Proposed Filling and Excavation of Land for Permitted Development of New Territories Exempted House (NTEH) at Lot 226 (Part) in D.D. 111, Pat Heung, Yuen Long, N.T.

Our response to the comments of the Fanling, Sheung Shui and Yuen Long East District Planning Office is found below:

SUBMISSION REPORT
FOR
DRAINAGE PROPOSAL DESIGN
FOR PROPOSED DEVELOPMENT
ON
LOT 226(PART) IN D.D.111

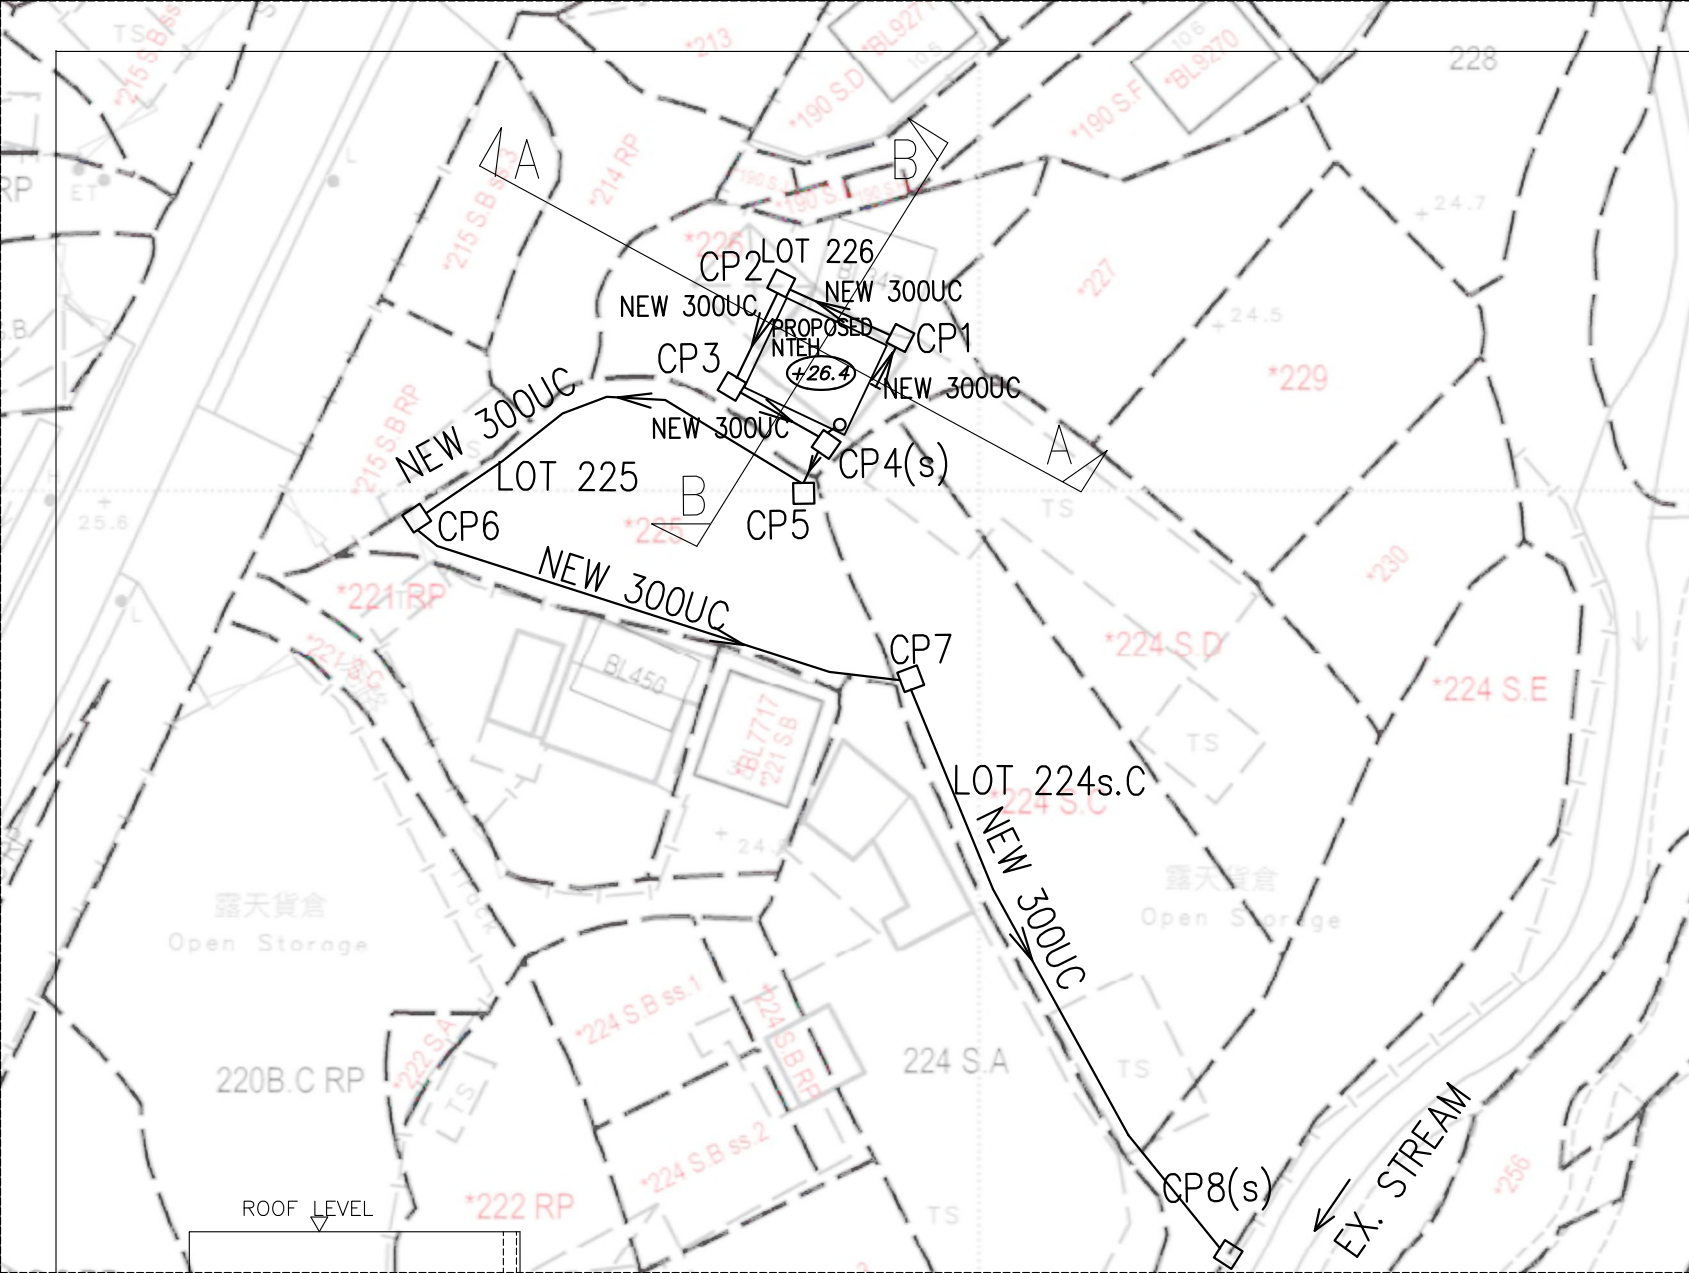
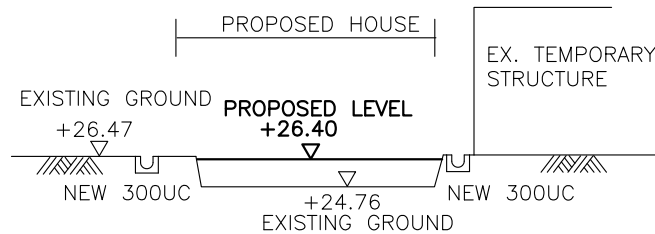
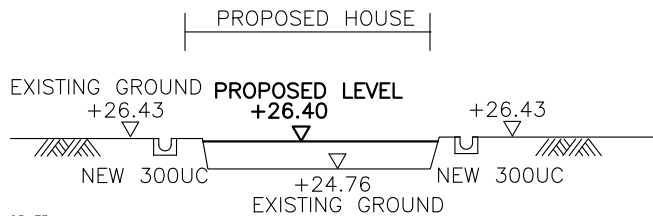
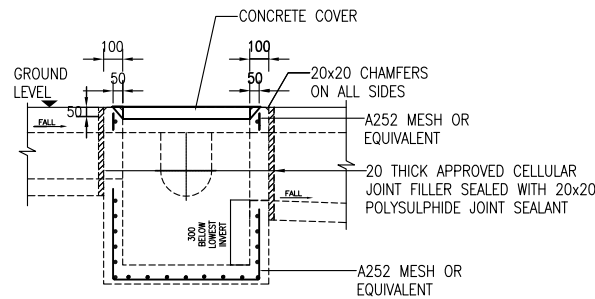
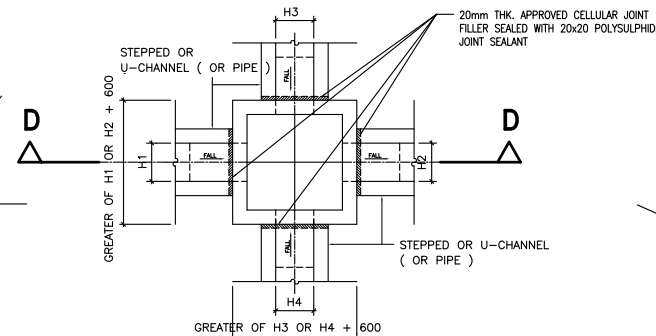
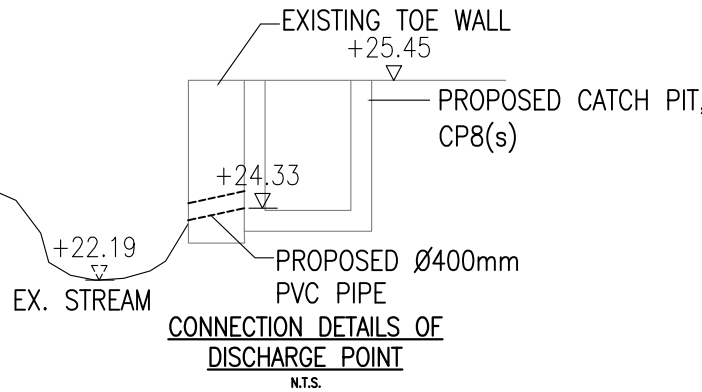
Fanling, Sheung Shui and Yuen Long East District Planning Office's comments	Applicant's response
1. Please provide a drainage proposal support the proposed filling of land.	Noted and please see attachment.

2. Please provide a detailed plan showing 1) the application site boundary, 2) the footprint of the proposed NTEH to be redeveloped, 3) the alignment of the proposed drainage channel, 4) the boundary of the proposed land filling area and 5) the boundary of the proposed land excavation area.	Noted. Please see attached plans.

The proposed stormwater drainage works include surface U-channels at the peripheral of the site collecting the runoff from catchments within the site. The U-channels will connect and discharge the surface runoff to the existing stream. Catchpits with 300mm sump are proposed at the discharged points of proposed U-Channel to desilt the surface water before discharging to the drainage outside. The proposed stormwater drainage layout plan is shown in **Appendix A**.

Sectional Plan of Lot 226 in D.D.111
D.D.111, Yuen Long

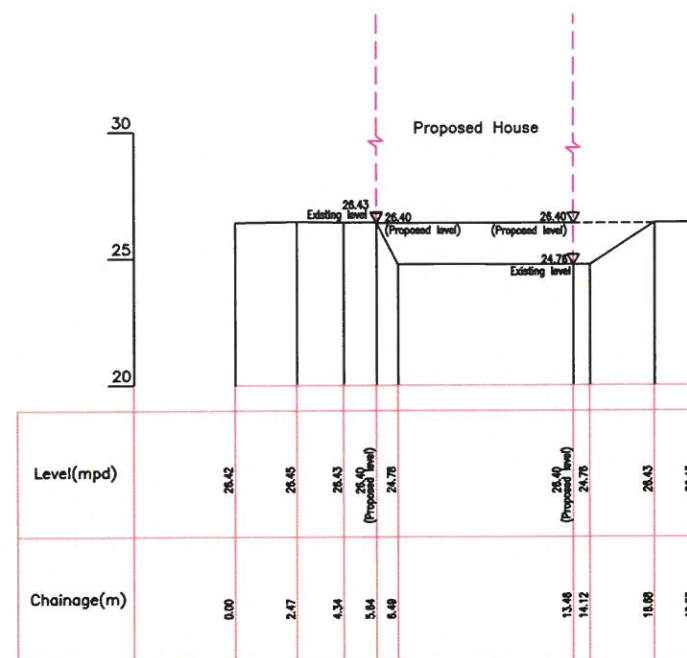
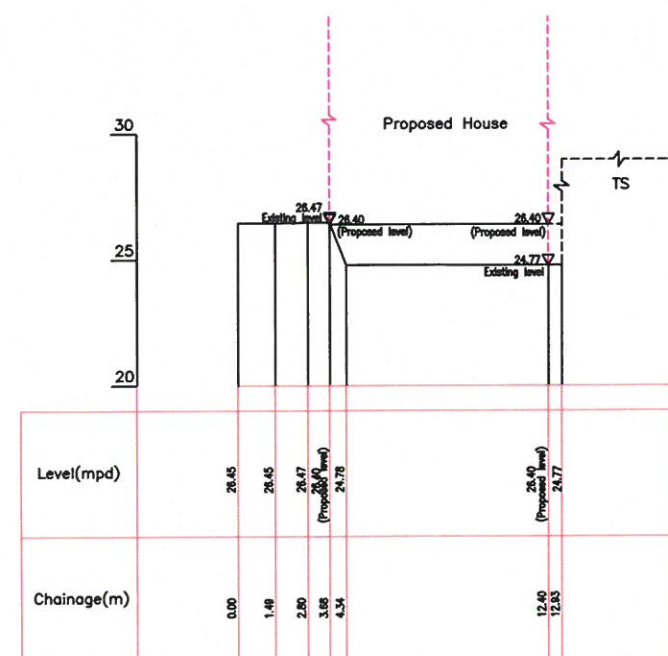
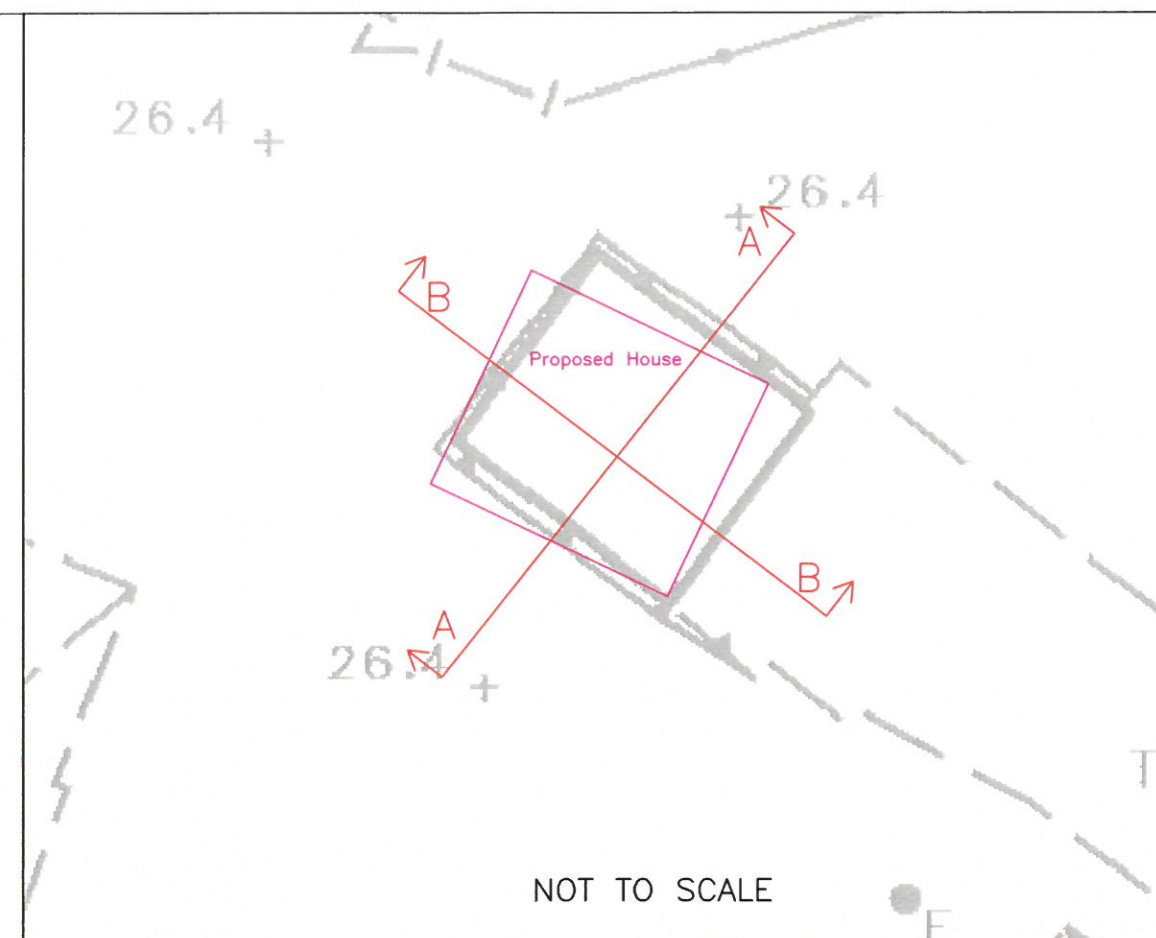
3. Please provide detailed section plans showing the proposed level of filling of land.	Noted. Please see attached plan.
4. Please advise the proposed fill materials for the proposed filling of land.	The filling materials for the proposed filling of land will be soil covered by concrete.
